SUBDIVISION REVIEW SHEET

CASE NO.: C8-2022-0112

SUBDIVISION NAME: Velocity Preliminary Plan

CITY OF AUSTIN –DEVELOPMENT SERVICES DEPARTMENT SUBDIVISION APPLICATION – MASTER COMMENT REPORT

Exhibit A: Vicinity Map

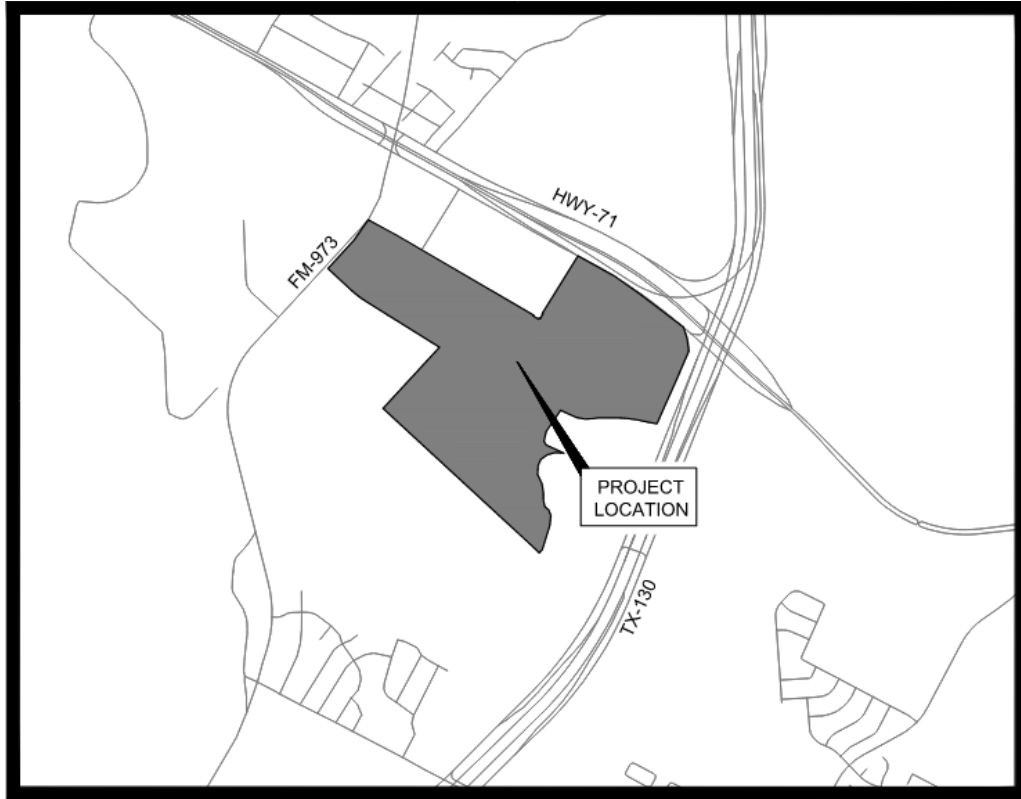
AD1. Please remove the punctuation marks and update label to read as follows **S FM 973 RD** the directional S must be included in the vicinity map §25-4-155

AD2. Please remove the punctuation marks and update label to read as follows **E SH 71** the directional E must be included in the vicinity map §25-4-155

AD3. Please remove the punctuation marks and update label to read as follows **S SH 130 SB** the directional S must be included in the vicinity map §25-4-155

GENERAL NOTES

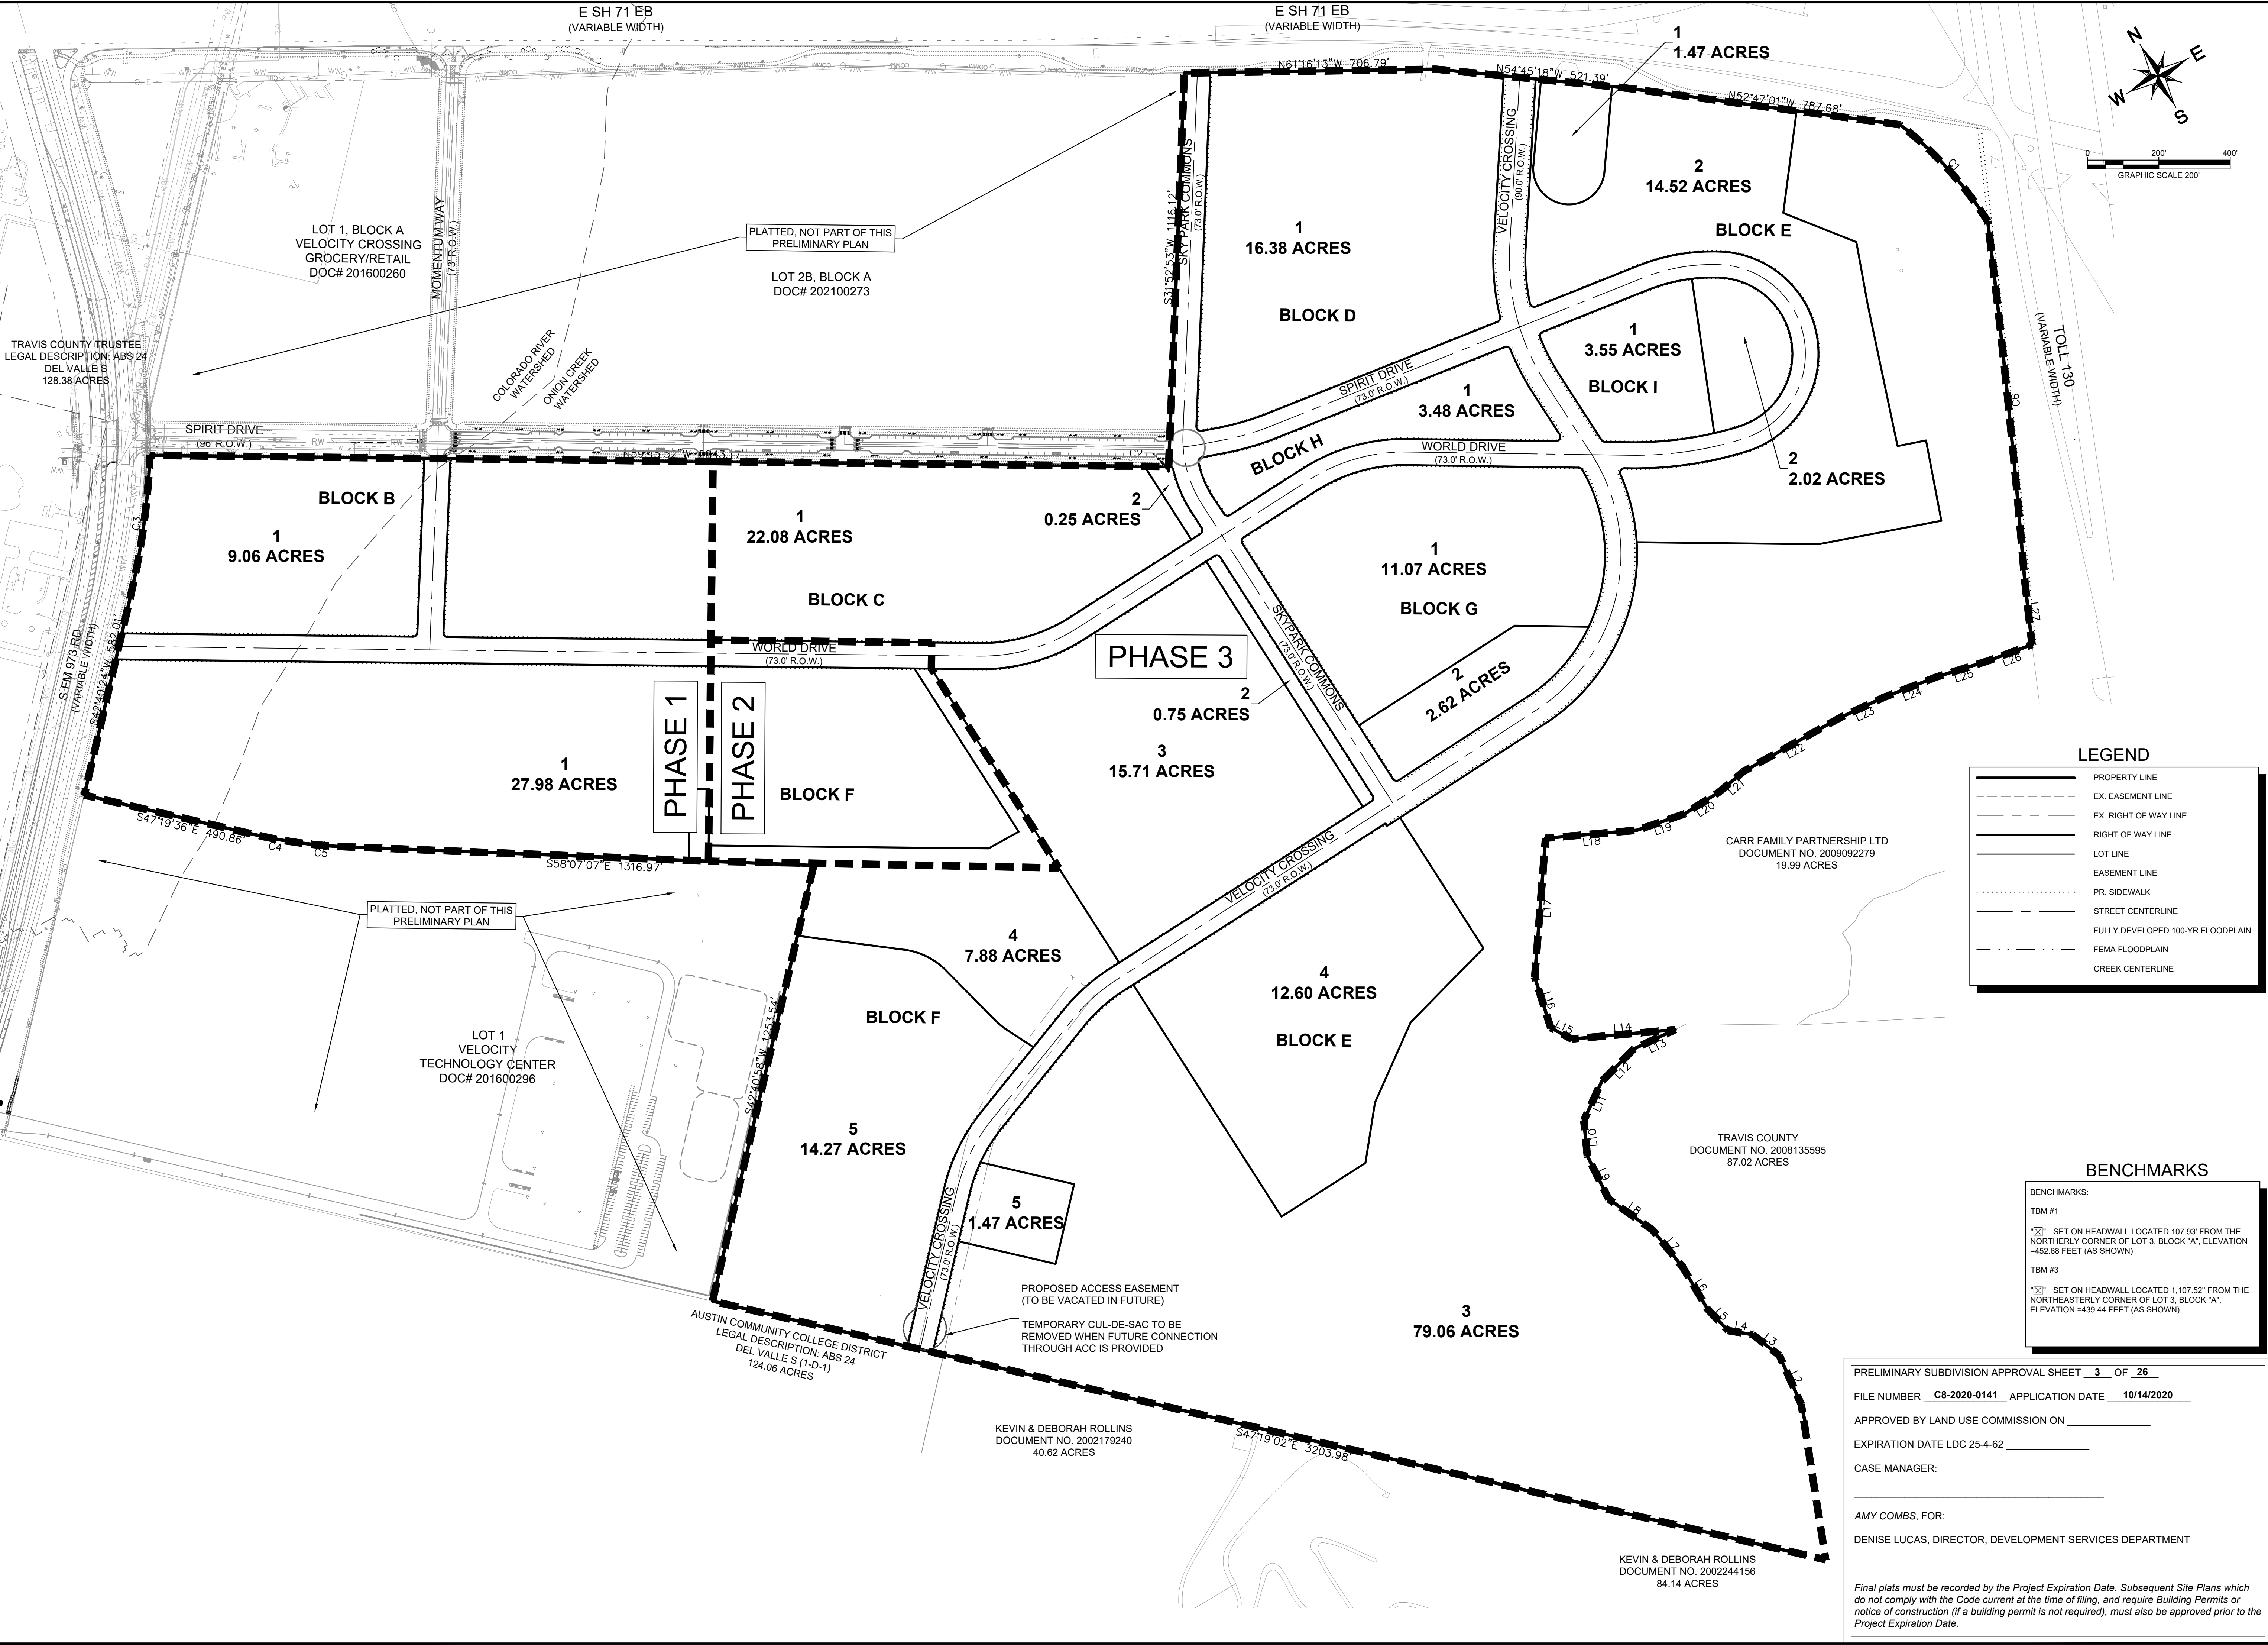
EV1. Remove the Q2 table on sh. 2 and replace it with the following note: A Q2 TABLE IS NOT REQUIRED FOR THIS PLAN. THE IMPERVIOUS COVER ALLOWANCE WILL BE REVIEWED WHEN THE INDIVIDUAL SITE PLANS ARE SUBMITTED. PER ECM 1.8.1.E, "FOR A COMMERCIAL SUBDIVISION WITH AN INTERNAL ROADWAY, THE PLATTED LOTS WILL NEED TO ACCOUNT FOR THE ROADWAY IF THE ROADWAY EXCEEDS THE IMPERVIOUS COVER LIMITS WITHIN THE RIGHT-OF-WAY."

SR2. Please revise note 12 on the preliminary plan to the below correcting the italicized section below and please correct Sky Park Commons elsewhere to the new street name if unable to use "Sky Park Commons" as a name (25-1-83):

- SR4.** Note 20 states that there is no known CEFs on the property, but then note 30 states that CEFs need to have a buffer, please coordinate with the wetlands biologist reviewer on what notes they would like to see on the plan (25-1-83)

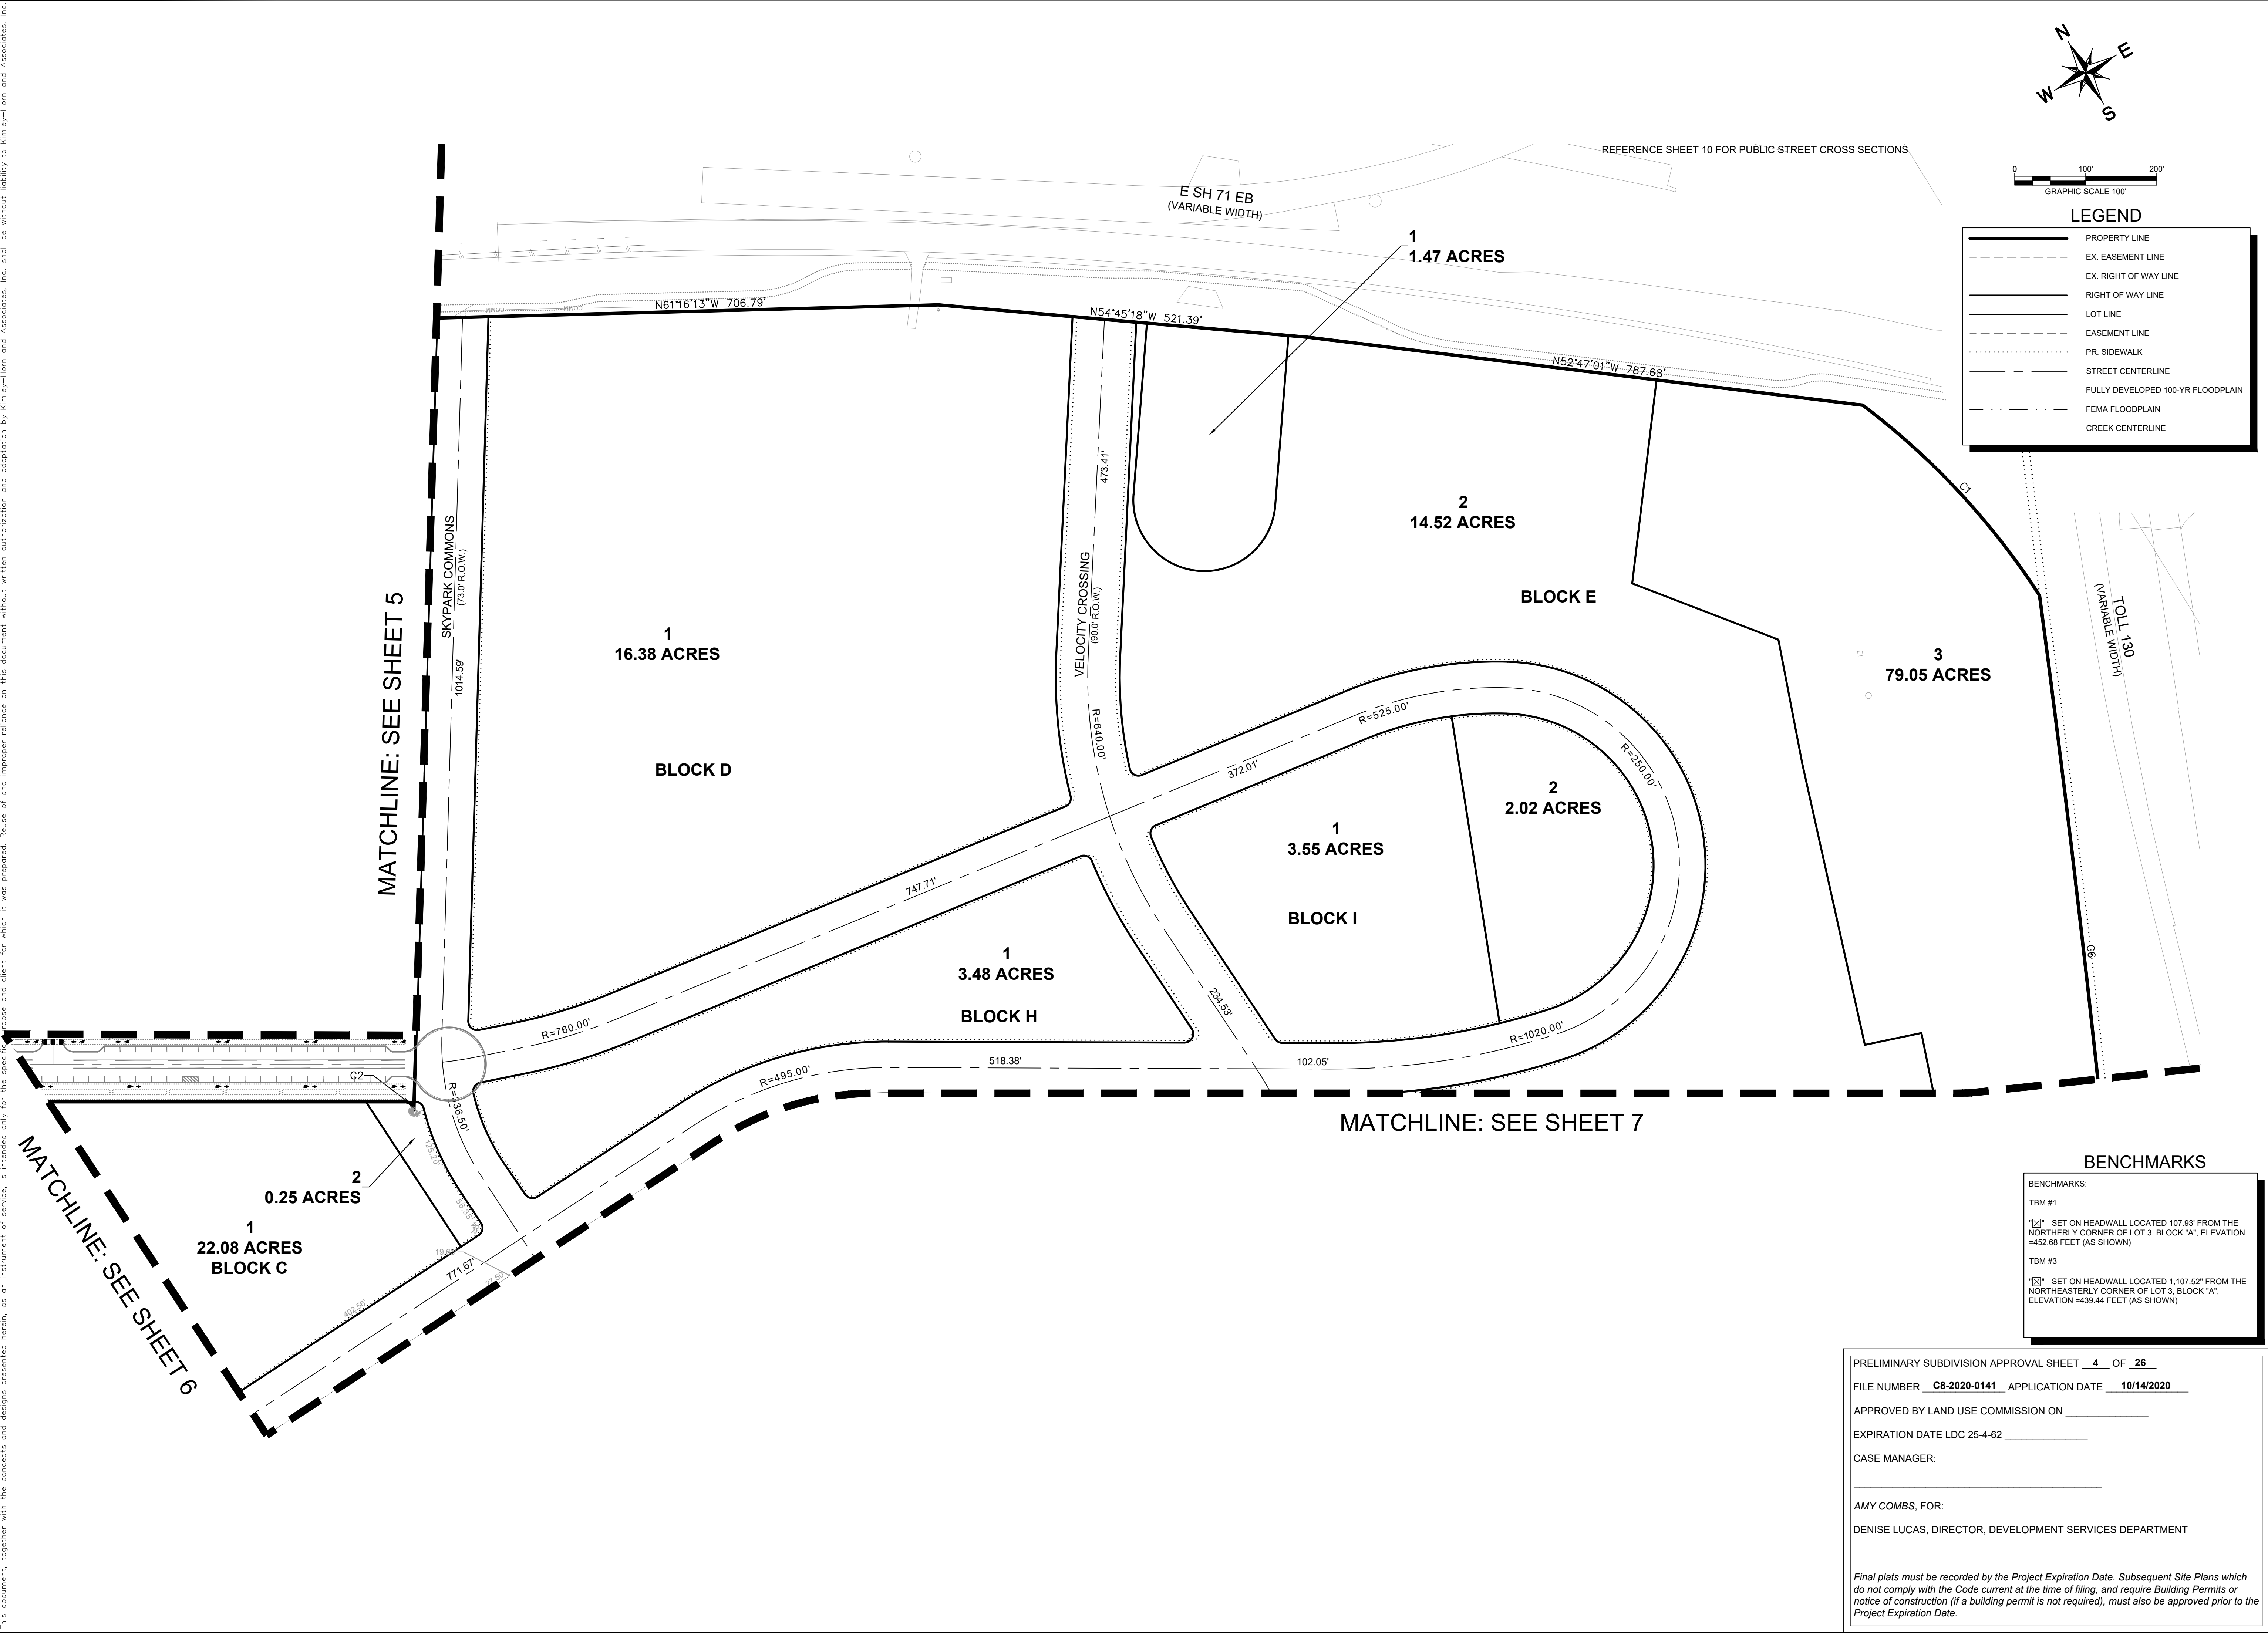
SR3. Please update the legend on the overall preliminary plan to show just what is on the face of the overall preliminary plan (25-1-83)

- SR9.** Please remove all of the building footprints from the surrounding property- for instance on sheet 3 and sheet 5 there appears to be contours or building footprints for the surrounding property (25-1-83)
